UNITED STATES PATENT AND TRADEMARK OFFICE

APPLICATION NO.	FILING DATE	FIRST NAMED INVENTOR	ATTORNEY DOCKET NO.	CONFIRMATION NO.
09/142,660	12/23/1998	RAINER HINTSCHE	60953/119	2492

Office Action Summary	Application No. 09/142,660	Applicant(s) HINTSCHE ET AL.	
	Examiner Bradley L. Sisson	Art Unit 1634

Fig. 1

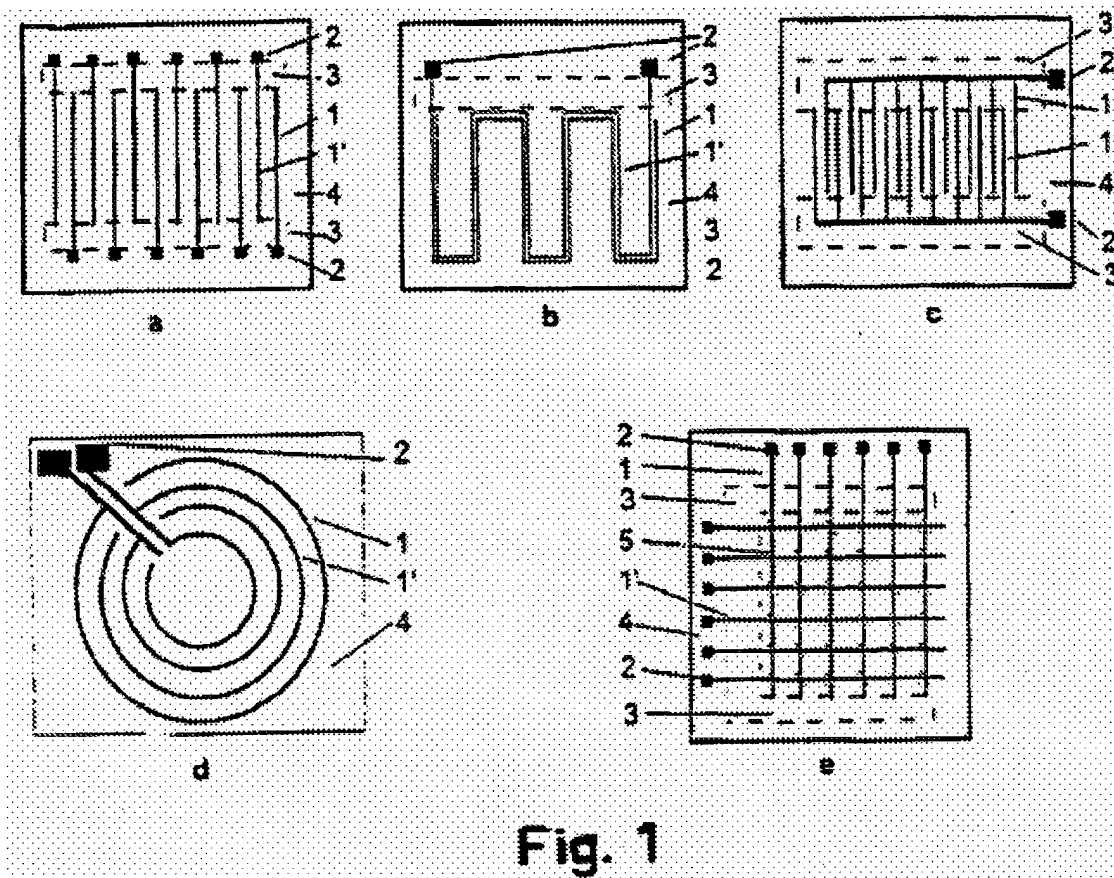
18. The above argument has been fully considered and has not been found persuasive towards the withdrawal of the rejection. The aspect of having multiple apertures arrayed along electrodes, even if the electrode material is continuous, is considered to meet the limitation that there are at least two electrode structures. In support of this interpretation, attention is directed to page 4 of the specification, which is reproduced below in pertinent part.

As can be seen in Fig. 1b, 1c, and 1d, there are but two electrodes present. As is plainly evident above, the ultra-microarray encompassed the very embodiment disclosed by the prior art.
